— Design Note

Client:	British Museum
Project:	39 Russell Square + Science Block
Project No:	119
Date:	18 November 2024
Author:	Joe Dent

This note outline’s three amendments proposed to be made to Application Ref: **2023/3252/P**, which involves refurbishment works to 39 Russell Square and the Science Block Extension. The three amendments include:

Figure 6: Section of amended scheme

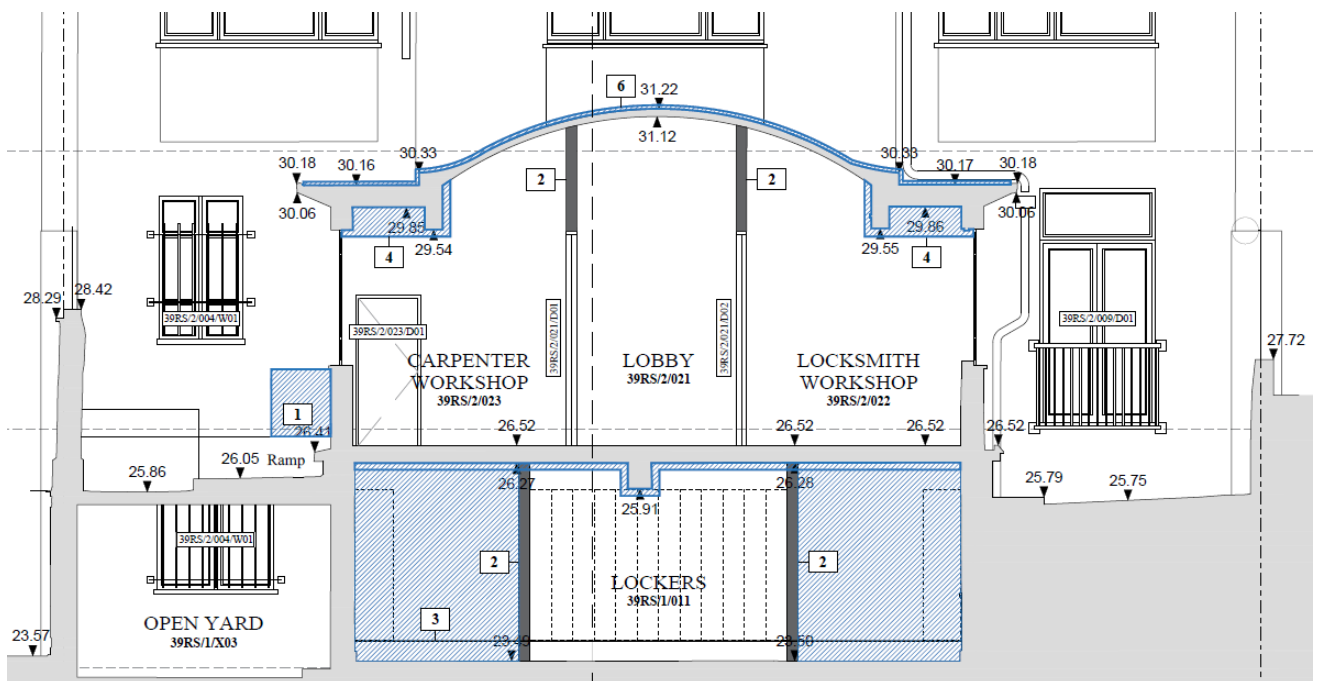
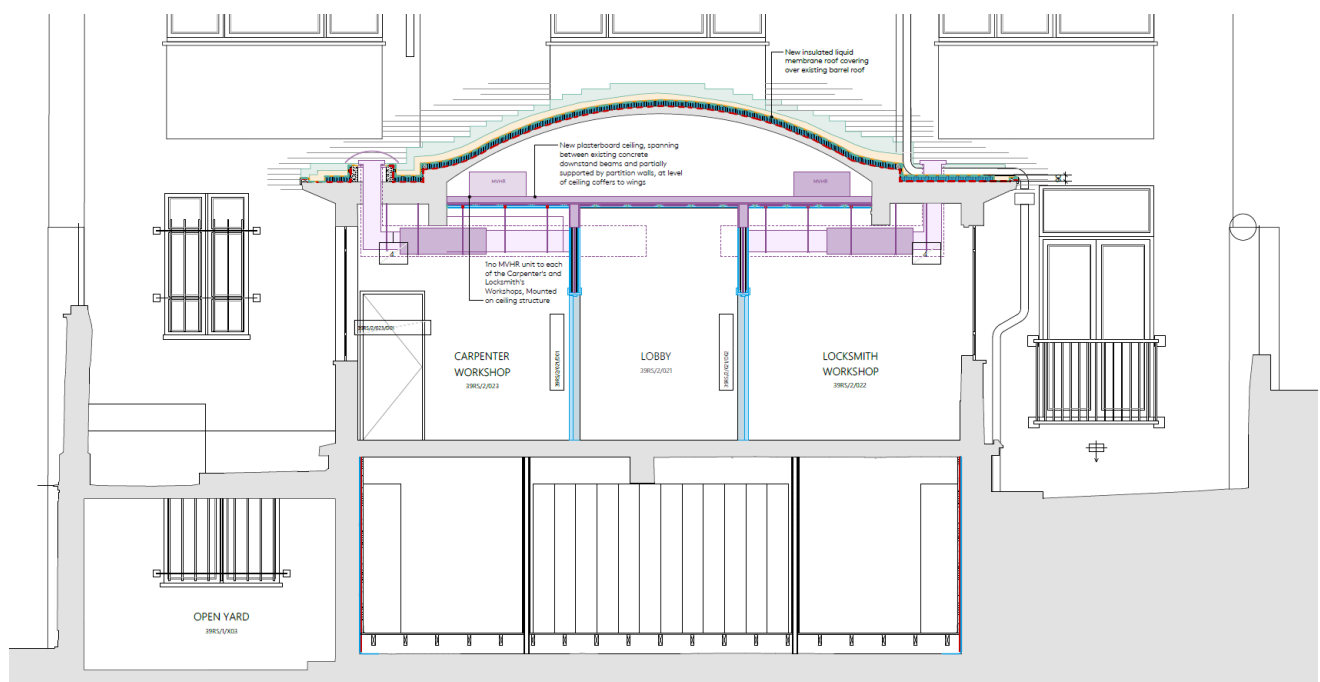
To prevent condensation forming on the roof, it is proposed that a thin layer of insulation is added to the proposed roof build up, to be introduced over the existing roof build up, beneath the new liquid applied waterproof covering. The new insulation is proposed to be 80mm, which will raise the roof level by a total of 90mm (including 10mm for the new roof covering). This additional height does not result in the need to raise any parapets or copings, and does not create a significant change in the roof height or edge profile.

Figure 8: Proposed elevation of west elevation of Science Block

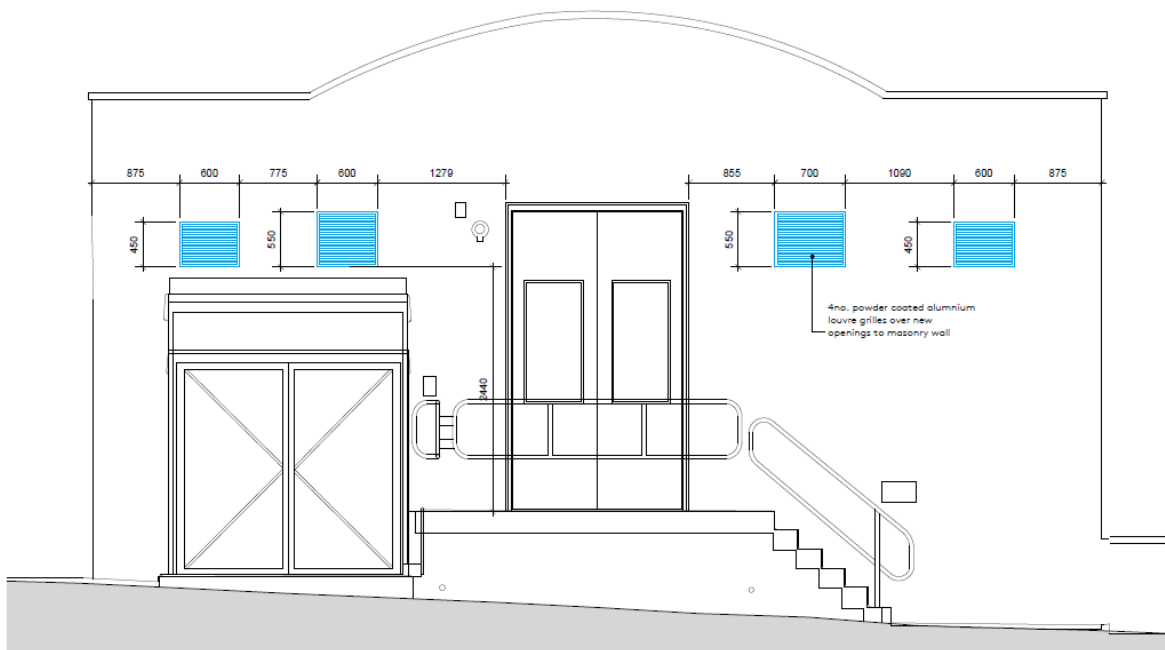
4no. new louvre grilles are proposed to be inserted in the west elevation of the Science Block. These are proposed to be added to allow for the increased airflow required to ventilate the workshop space, established following the development of the ventilation scheme through Stages 4 and 5.

The new grilles are to be formed of powder coated aluminium and have been aligned in a row on the west elevation to have as little visual impact as possible.

Figure 10: Proposed plan for new steps and handrail within yard of Science Block

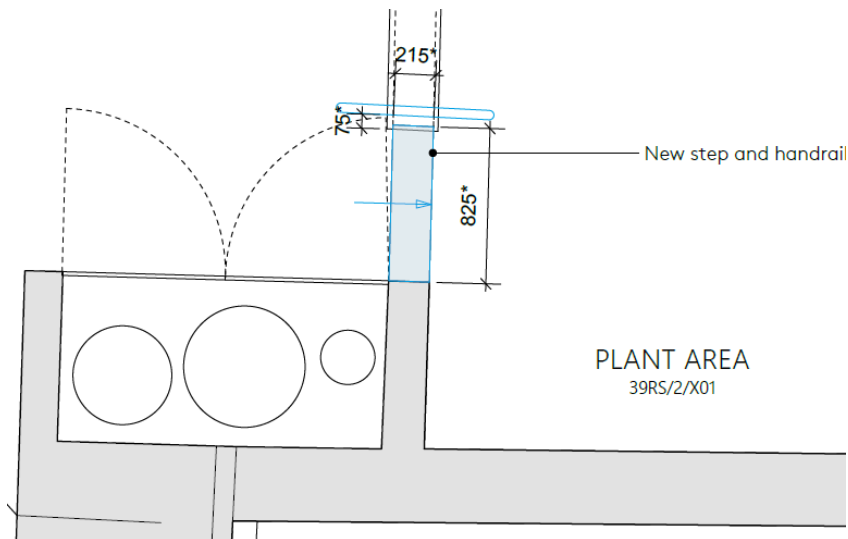
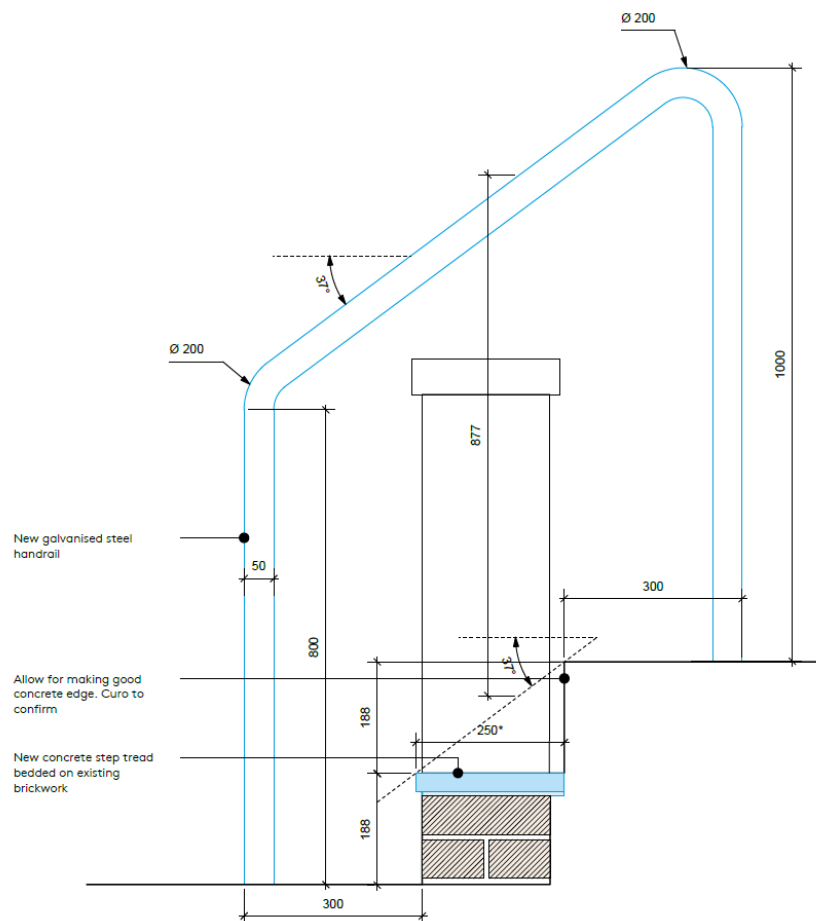
To make access to the south yard safer, it is proposed to form an intermediate step, to break the transition into 2no. steps of 168mm for each rise. A galvanised steel handrail is also proposed to be added by these steps.
